Notice of Intent

Type of Action: APD Change

XTO respectfully requests approval to make the below listed changes to the approved APDs.

WELL NAME	API Number
JRU Apache Federal Com 111H	30-015-56010
JRU Apache Federal Com 801H	30-015-56011
JRU Apache Federal Com 901H	30-015-55834
JRU Apache U Federal Com 704H	30-015-56188
JRU Apache Federal Com 705H	30-015-56229

Previous Design: 4-String Design – Engineered Weak Point**[Figure F] 4 String – 2nd Intermediate casing engineered weak point**

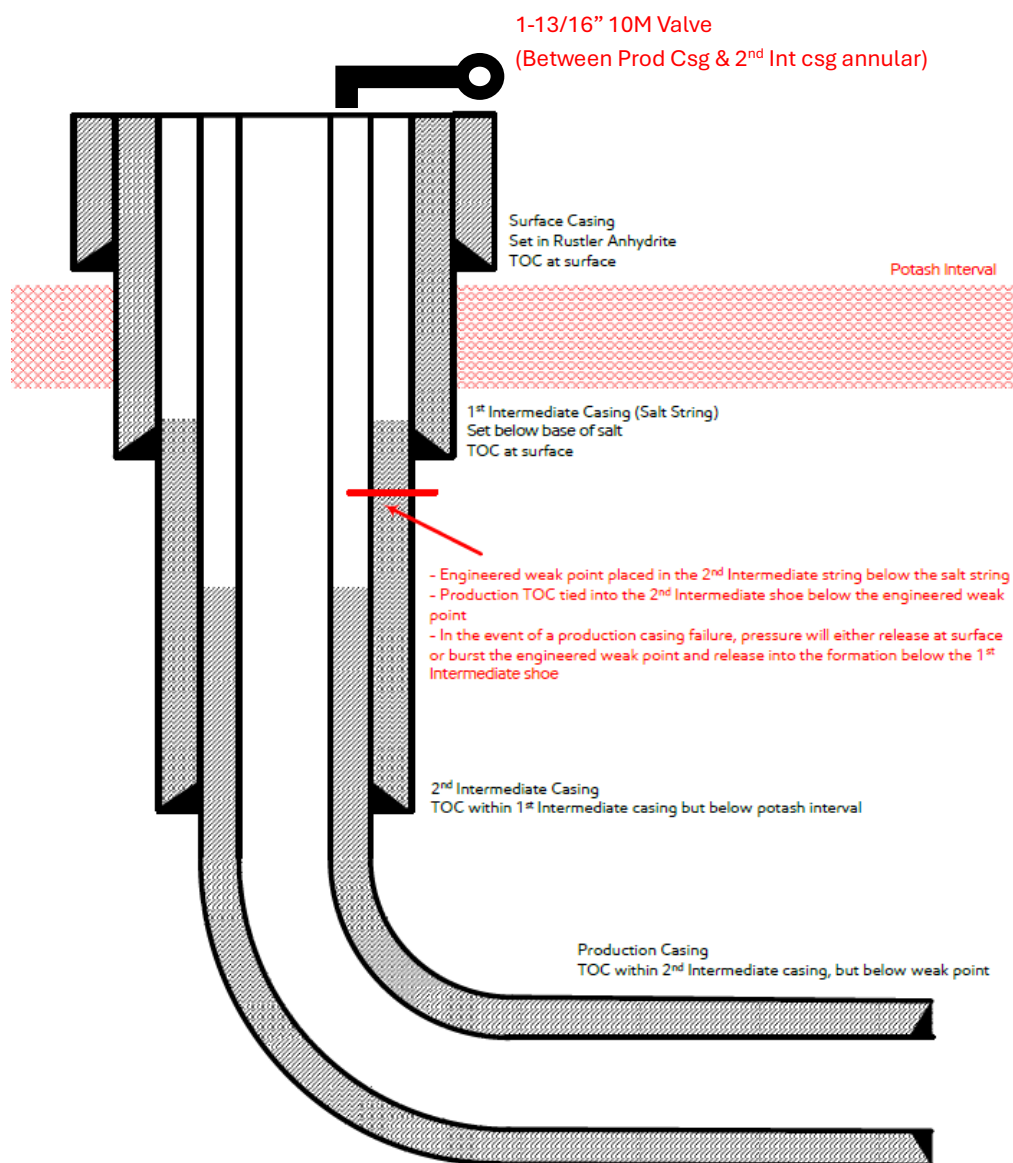
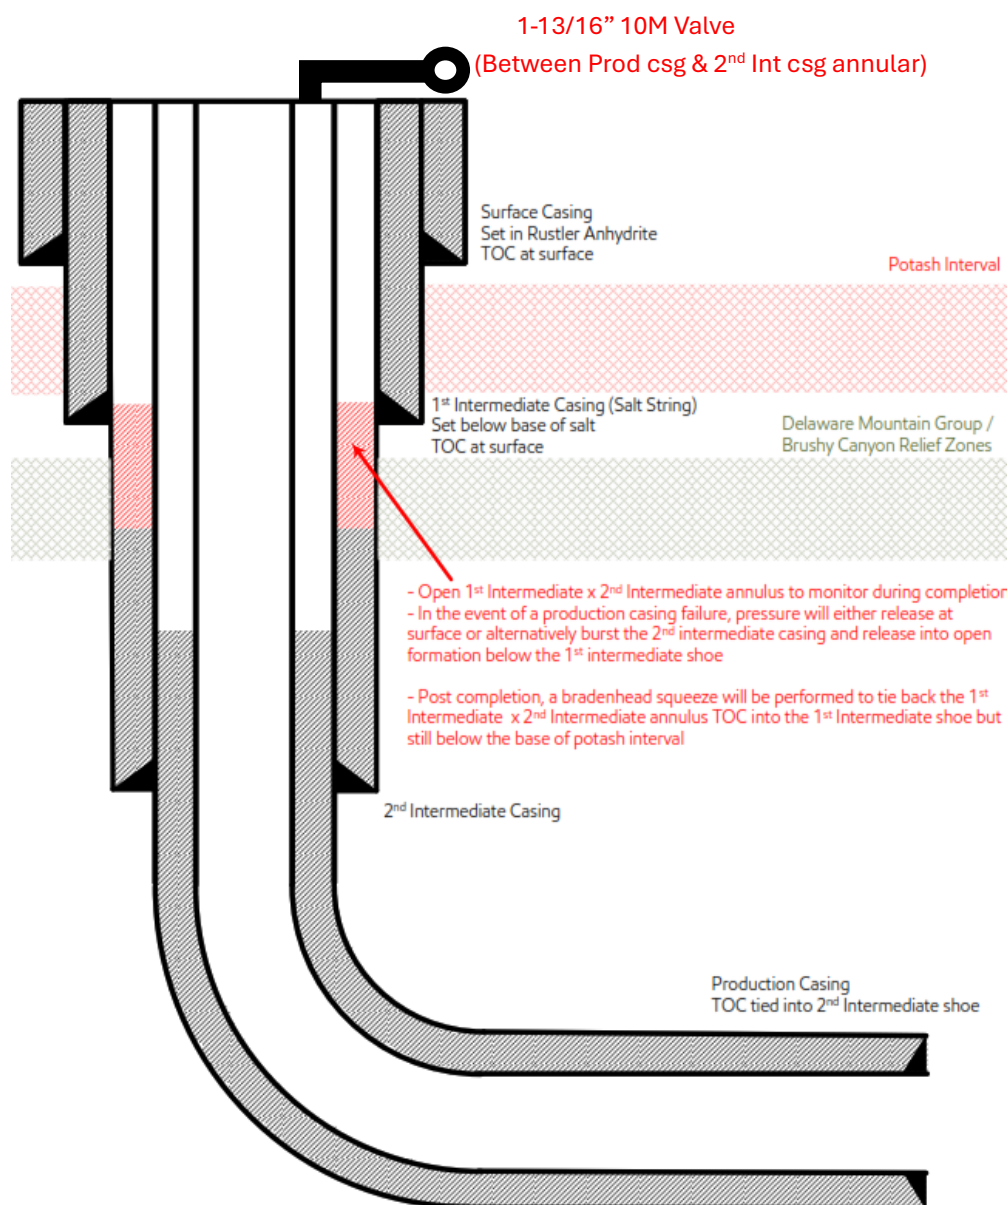
1. Casing design to be changed from the "4-String Design – Engineered Weak Point" (FIGURE F) to the "4-String Design – Open 1st INT x 2nd INT Annulus" (FIGURE D). An open annulus will be utilized and monitored during completions operations.

Post completion, bradenhead squeeze will be performed to tie back the 1st intermediate x 2nd intermediate annulus. TOC will be placed into the 1st intermediate shoe but still below the base of Potash interval.

New Proposed Design: 4 – String Design – Open 1st Int X 2nd Int Annulus (ICP 2 below relief zone)

[Figure D] 4 String – Uncemented annulus between 1st and 2nd intermediate casing strings

- 1) Alignment with KPLA requirements per schematic above, leaving open annulus open for pressure monitoring during frac and utilizing new casing that meets API standards.
- 2) Contingency plans in place to divert fluids away from salt interval in event of production casing failure.
- 3) Intermediate 2 bradenhead squeeze to be completed within 180 days to tieback TOC to salt string at least 500ft but with top below Marker Bed 126.
- 4) Production cement to be tied back no less than 500ft inside previous casing shoe.
